**PLANNING DEPARTMENT
CURRENT PLANNING DIVISION
DIMENSIONAL VARIANCE**

DATE October 10, 2024
CASE NO: 2024-0091
APPLICANT: Casey & Kirsten Brogan (Owners)
REPRESENTATIVE: Jeremy Hurst (49th Star Surveying)
REQUEST: Dimensional Variances from: 1) AMC 21.09.060 Table 21.09-5 Table of Dimensional Standards: Girdwood Residential Districts to allow the cabin closest to Higher Terrace to encroach into the front setback; and 2) AMC 21.07.020B.9. Table 21.07-1. Minimum Stream Setback Width Per Side to allow the same cabin to encroach into the 25-foot stream setback.
LOCATION: Generally located north and northwest of Higher Terrace, east and south of Alyeska View Avenue
LEGAL DESCRIPTION: Alyeska Subdivision, Third Addition, Block 21, Lot 17 (Plat 66-167)
SITE ADDRESS: 241 Higher Terrace
COMMUNITY COUNCILS: Girdwood
TAX PARCEL NO.: 076-022-30-000
GRID: SW4916

AS BUILT/PLOT PLAN SURVEY
 Lot 17, Block 21,
 Alyeska Subdivision,
 Add. 3, Girdwood, AK

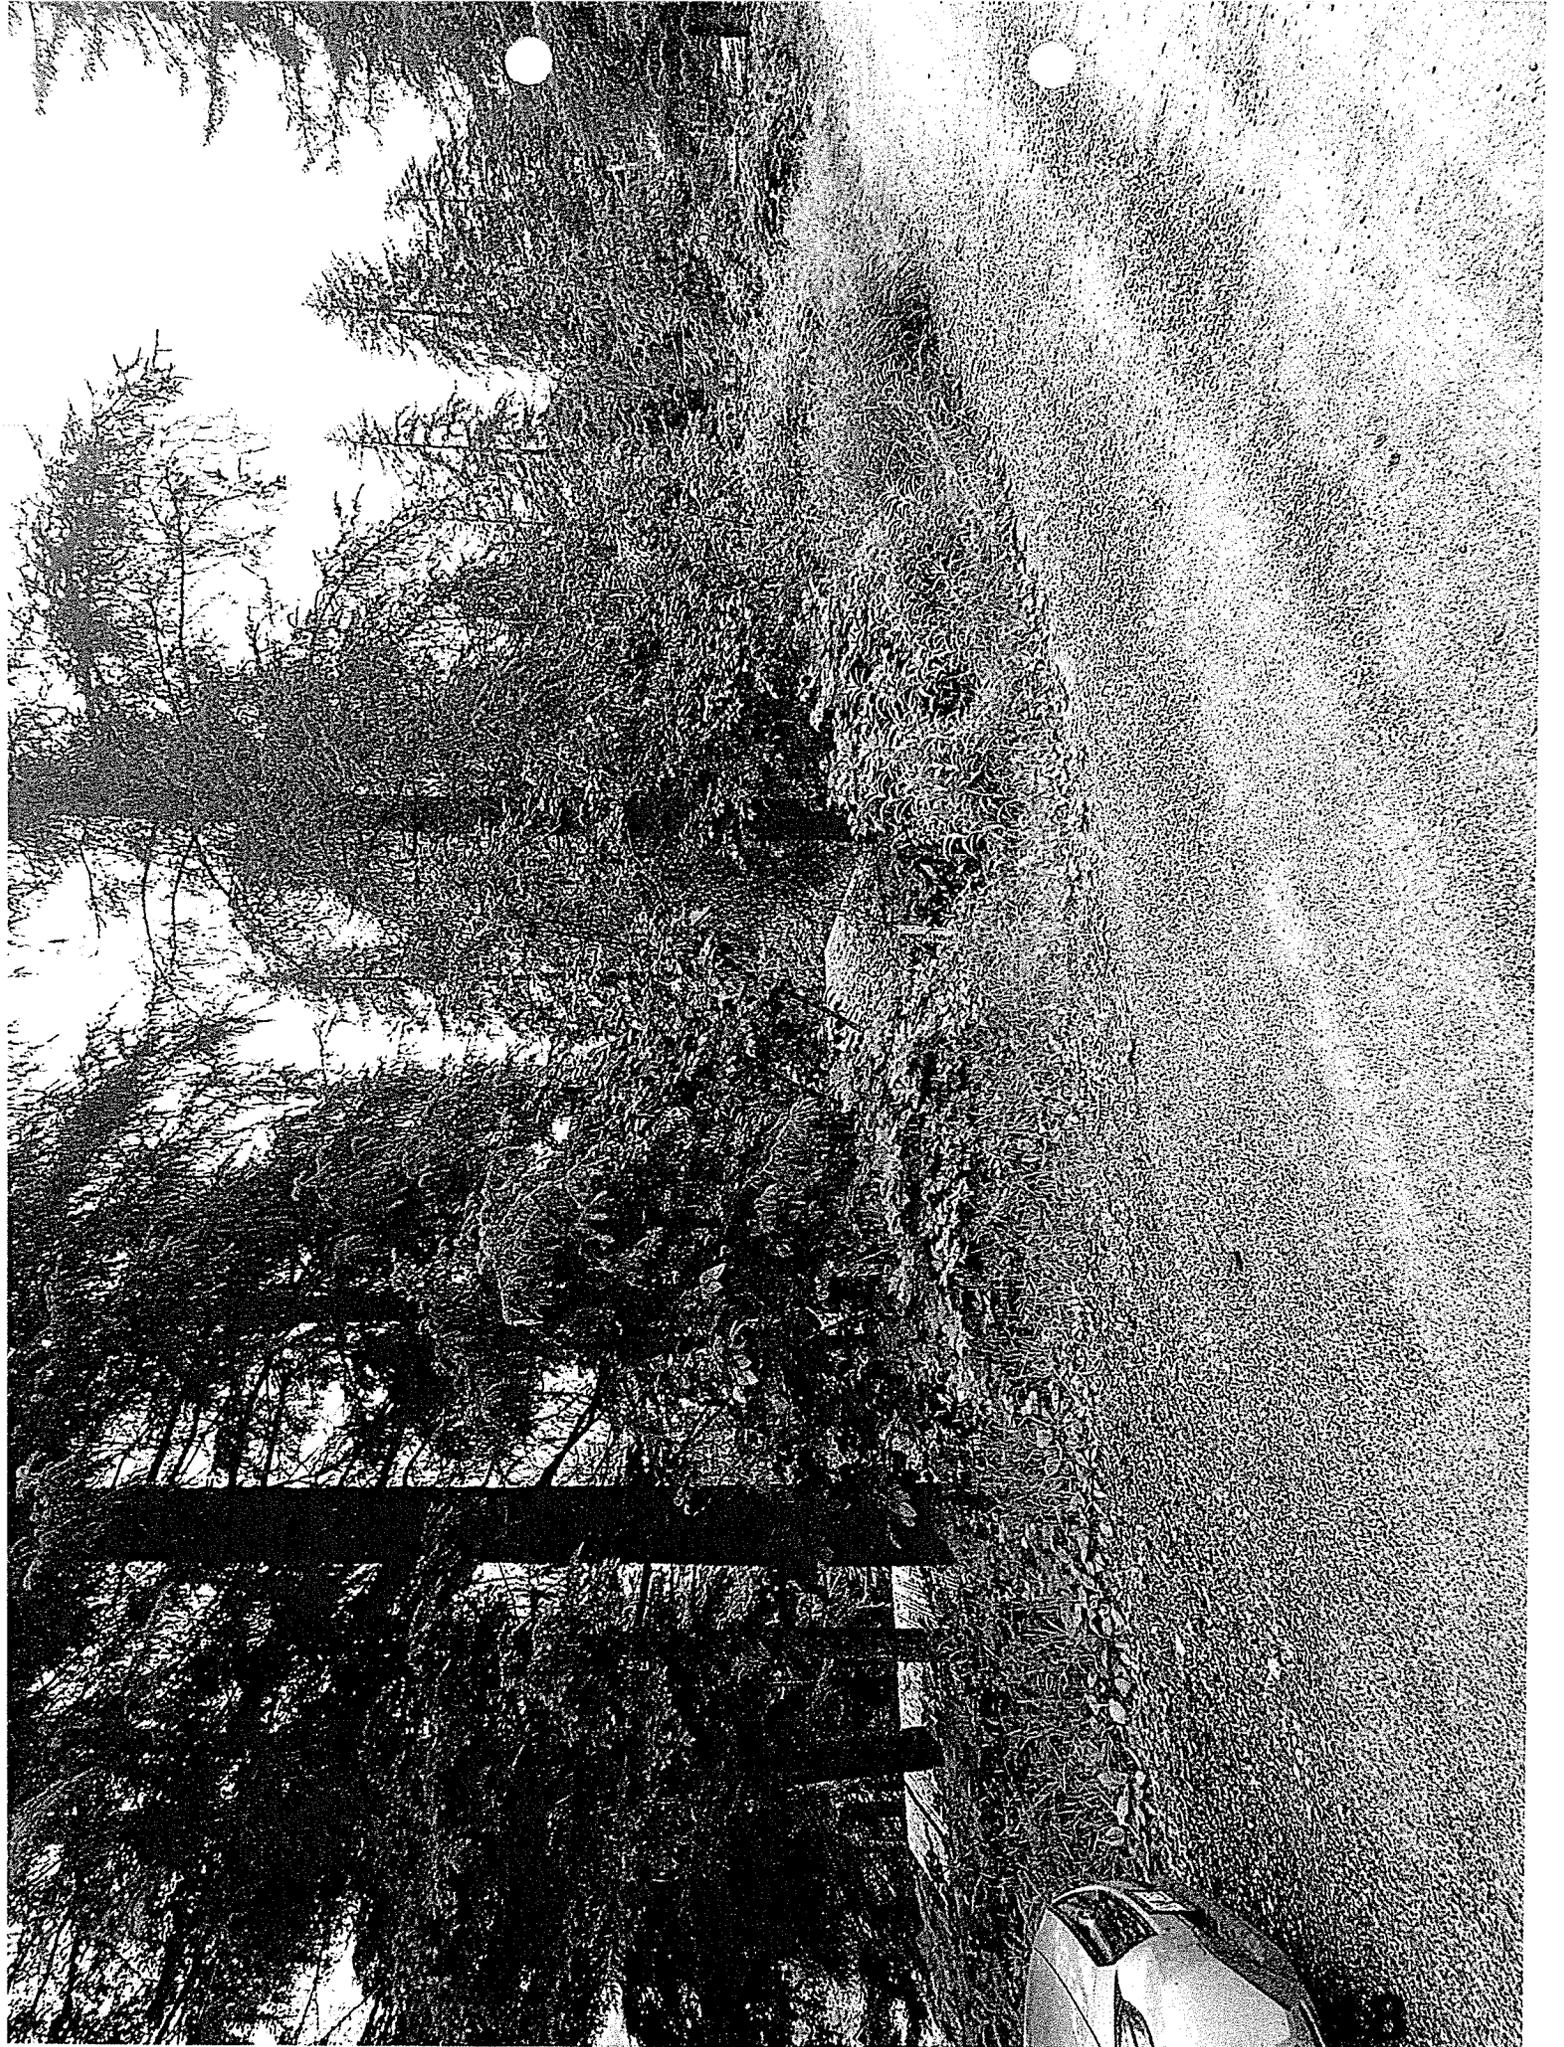
2. Post addresses for both structures along Higher Terrace and on the structures.
3. Remove "Prop. Parking" from the as-built/plot plan. Parking is not required but if provided must be on property and not within the dedicated Right-of-Way.

Traffic Engineering has no objection to approval of the dimensional variance for front and stream setback. The plot plan dated January 16, 2024, shows property parking and two walkways located with public right of way. If parking is required to be provide for this land use, then it needs to be located on property. Recent amendment to title 21 eliminated required parking. Recommend that this be eliminated from plot plan.

- 2024-0091 – Lot 17, Block 21, Third Addition, Alyeska Subdivision (Plat 66-167);
 - Stream mapping shown in the variance documents is different from what current MOA stream mapping shows. Please contact WMS to request stream mapping so that the stream location can be verified and mapping updated.
 - WMS is supportive of the variance to allow Cabin 1 to remain within the stream setback as long as the setback encroachment is not increased by the remodel/redevelopment of the existing cabin (the variance documents state that the proposed improvements will occupy the same building footprint).

Case 2024-0091, Variance for Alyeska #3 Block 2, Lot 17, SE4916

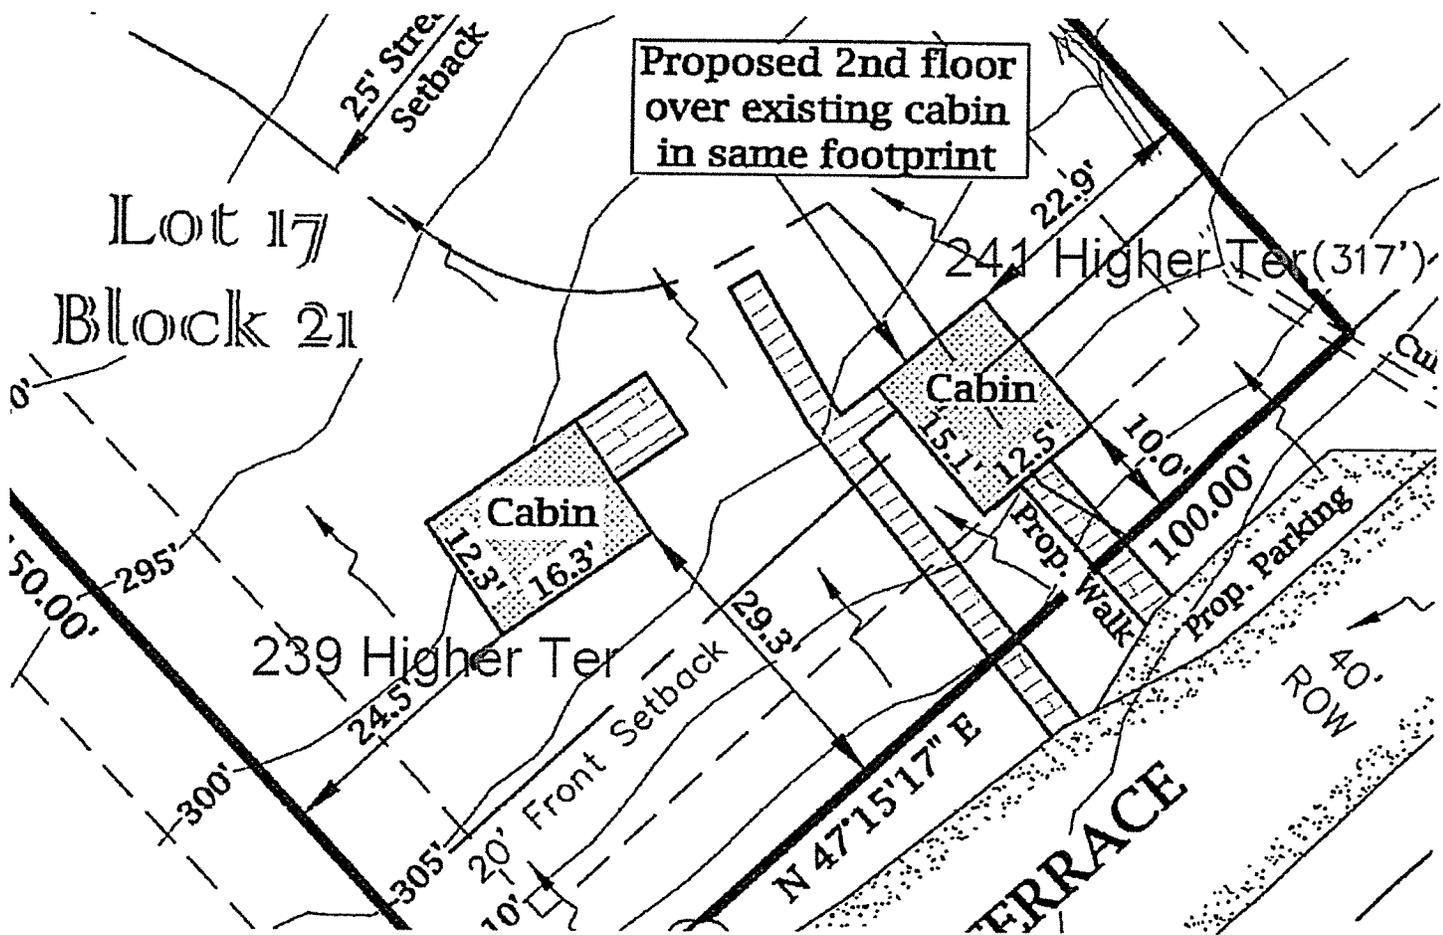
- a. Address Requirement:
- When addresses were assigned in Girdwood, Addressing was aware of only 1 cabin.
 - See map for address assignments
 - Both addresses must be posted at the road as well as on the structures
